**Re: Planning and Zoning Commission recommendation to deny without prejudice the Preliminary Plat of Field's Edge Addition, an eight (8) lot residential Major Subdivision located in part of SW $\frac{1}{4}$ NW $\frac{1}{4}$  of Section 7, Pleasant Valley Township..**

PLANNING & ZONING COMMISSION  
STAFF REPORT  
May 19, 2020

# **Preliminary Plat – Major Subdivision Field’s Edge Addition**

**PRELIMINARY PLAT OF  
 FIELDS EDGE ADDITION  
 SCOTT COUNTY, IOWA**

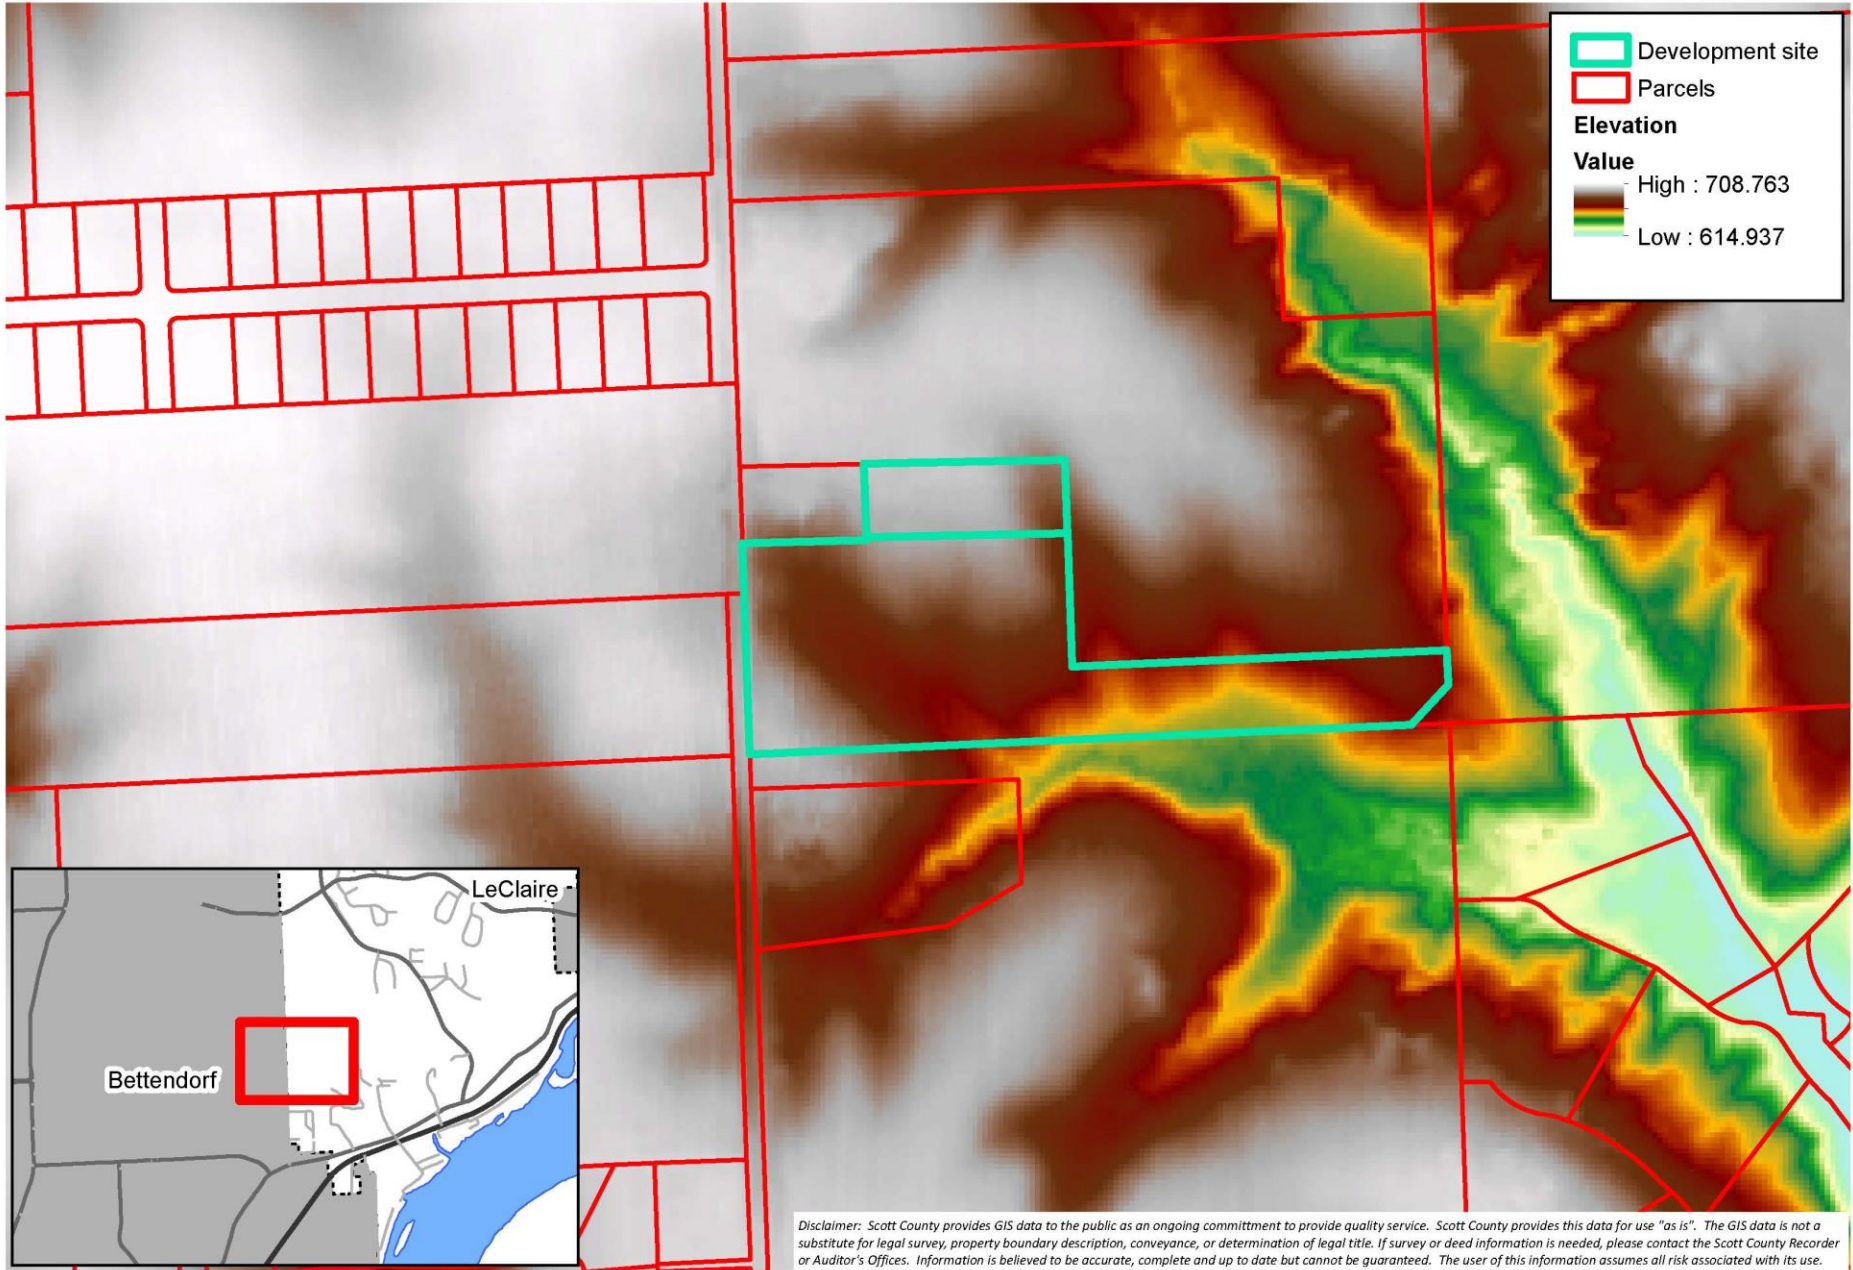
Due to the configuration of the property the layout still shows two lots on the north portion of the property with "flagpole" access to the private drive as the sketch plan had. Both sketch plan reviews recognized all lots meeting the minimum 30,000 square foot lot size requirement. However, a subdivision regulation, specifically addressing flaglot size requirement was not applied. Scott County Subdivision Ordinance Section 9-17 F.(4) states, "*Flag lots are permitted if the stem is at least twenty (20) feet wide from the street to the buildable portion of the lot. The stem must be located where it is reasonable to construct a private drive from the street to the principal building. The buildable portion must meet the minimum area requirements for that particular zoning district.*" Excluding the stem from the access flagpole, Lot 3 has a buildable portion area of 27,783 square feet and Lot 4 has a buildable portion area of 29,400 square feet. Scott County Zoning Ordinance prescribes a minimum lot size of 30,000 sq. ft. for Single-Family Residential (R-1). Therefore, Lot 3 and Lot 4 do not meet the minimum lot size requirement. Lots 1-2 and 5-8 all meet the minimum lot size requirement.

1. The buildable portion area of Lot 3 and Lot 4 each meet or exceed 30,000 square feet;
2. The private covenants include provisions for the ownership and maintenance of the proposed outlot;
3. The private covenants include provision for road maintenance of the private road; and
4. The County Engineer review and approve all street construction plans, drainage plans, and erosion control plans following preliminary plat approval and prior to construction.

**PRELIMINARY PLAT OF  
 FIELDS EDGE ADDITION  
 SCOTT COUNTY, IOWA**

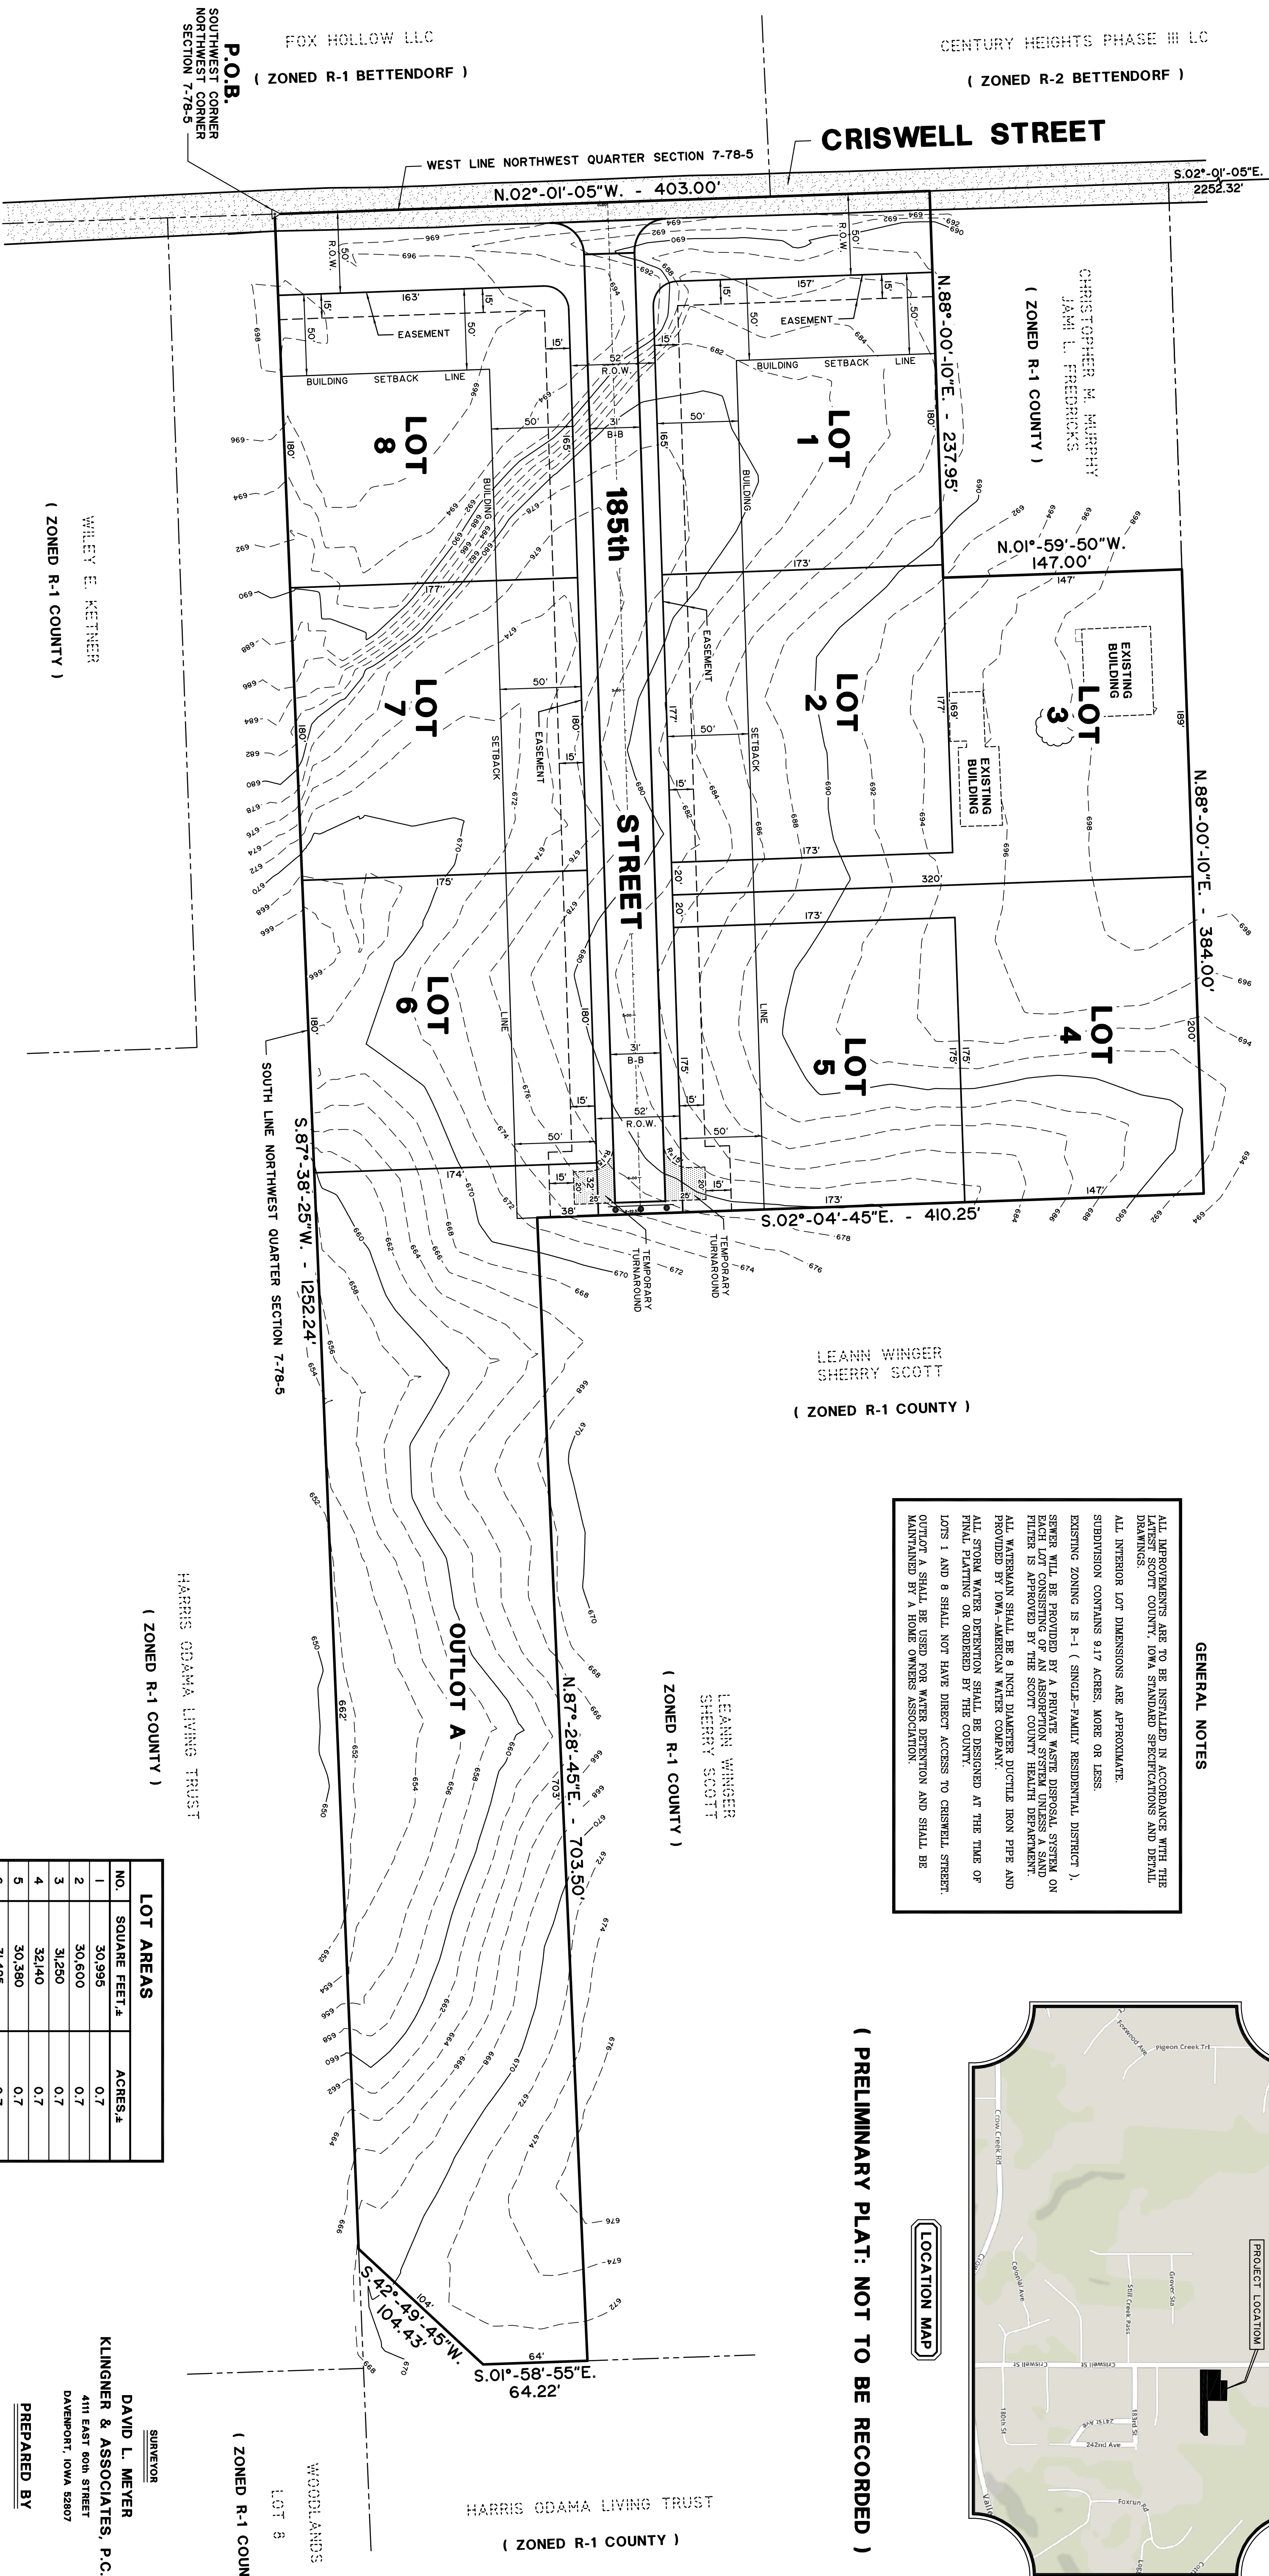
A reconfigured plat has been submitted in which ALL lots meet minimum lot sizes, including Lot 3 and Lot 4. The twenty (20) foot flagpole stem for Lot 3 and Lot 4 has been reduced to fifteen (15) feet. The applicant is proposing a shared driveway, bisected by Lot 3 and Lot 4 flagpole stems. The applicant has stated a shared maintenance agreement would be included for each Lot 3 and Lot 4.

- The residential lots range in size from a cumulative size of 0.69 acres to 0.73 acres.
  - Scott County Subdivision Ordinance Section 9-17 F.(4) states, *“Flag lots are permitted if the stem is at least twenty (20) feet wide from the street to the buildable portion of the lot. The stem must be located where it is reasonable to construct a private drive from the street to the principal building. The buildable portion must meet the minimum area requirements for that particular zoning district.”* Lot 3 and Lot 4 are both proposed flagpole lots and do not meet the minimum lot size requirement when excluding the area of the stem of the flagpole. Without the “stem”, Lot 3 has a building area of 27,783 sq. ft. and Lot 4 has 29,400 sq. ft.

**RECOMMENDATION:** Staff recommends that the request by Ryan Dolan DBA Edgebrooke Homes for fifteen (15) feet wide flag lot access stems in lieu of the twenty (20) feet wide prescribed by Section 9-16.F.(4) of the Subdivision Ordinance be approved with two conditions:

- 1. The buildable portion area of Lot 3 and Lot 4 each meet or exceed 30,000 square feet;**
- 2. The private covenants include provisions for the ownership and maintenance of the proposed outlot;**
- 3. The private covenants include provision for road maintenance of the private road; and**
- 4. The County Engineer review and approve all street construction plans, drainage plans, and erosion control plans following preliminary plat approval and prior to construction.**
